October 26, 2022

RE: Definitive Subdivision Plan for Peyton Estates,
Off Squirrel Island Road, Wareham, MA

JC Engineering has received comments from Charles L. Rowley, PE, PLS, dated October 3, 2022 pertaining to the proposed development of Peyton Estates (Off Squirrel Island Road, Wareham) and offers the following in response (*Mr. Rowley's comments in italics*):

DRAINAGE AREA
PEYTON ESTATES
W. WAREHAM, MA 02576

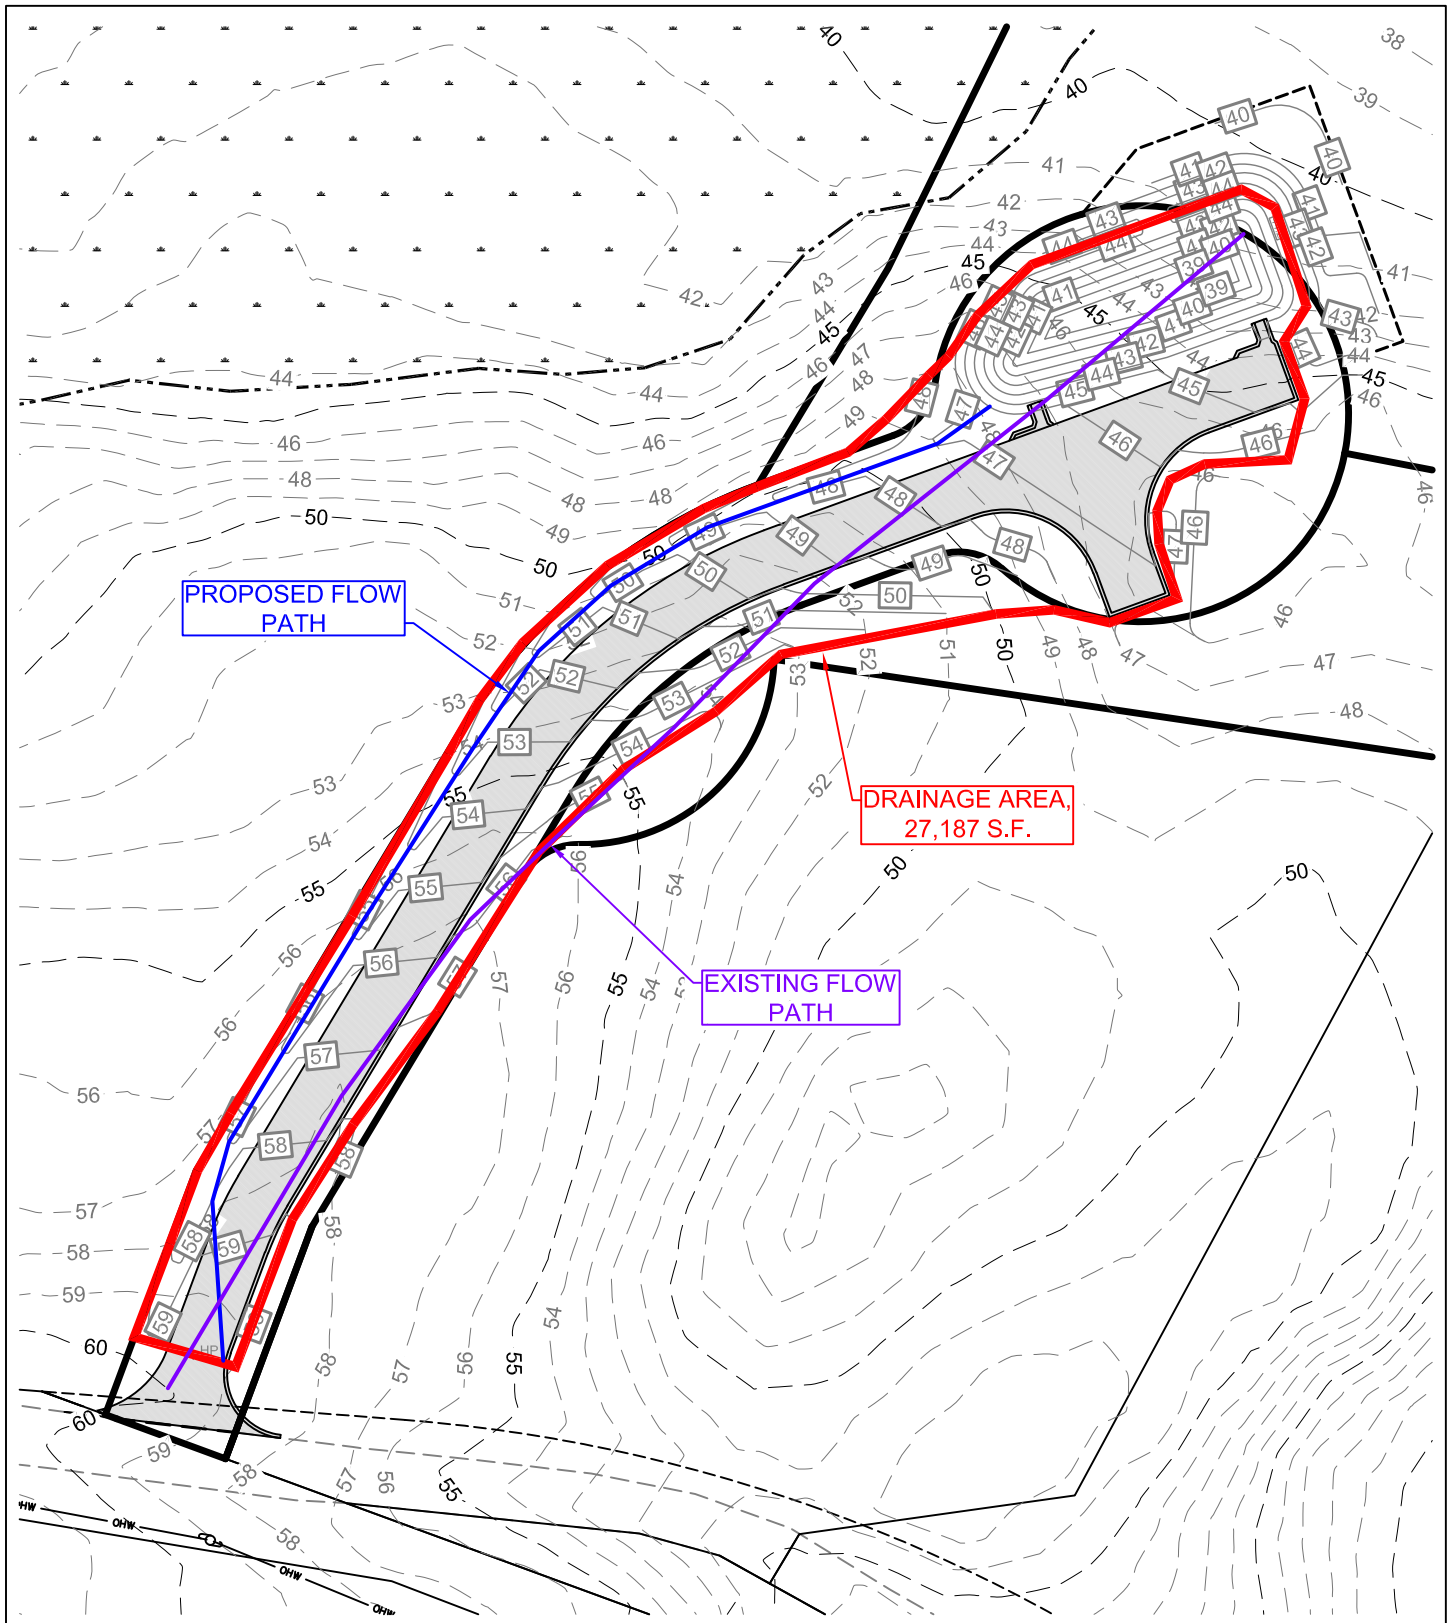
1. *The drainage report is not supported by information that shows what the soil conditions are like on site. Soil tests should be performed in the proposed infiltration area to show that infiltration will actually work. Additional test pits have been completed on either end of the proposed infiltration basin. The test pit data is included on the revised plan set.*

2. *Adequate infiltration may not be provided with a grassed surface. The rate should be checked to be sure that infiltration will not be impeded by frozen surfaces during the winter months. A note says that contact should be made with soils in the "C" layer but this layer has not been confirmed.* The infiltration basin was designed using a Rawls infiltration rate for Sandy Loam materials (1.02 in/hr). The additional test pits confirm that the soils are consistent with the sizing calculations for the infiltration basin.

3. *There needs to be information to show that the infiltration basin will have at least a two (2) foot separation to high ground water.* Additional test pits have been completed on either end of the proposed infiltration basin. Groundwater has been determined to be at least 2 feet below the bottom of the infiltration basin.
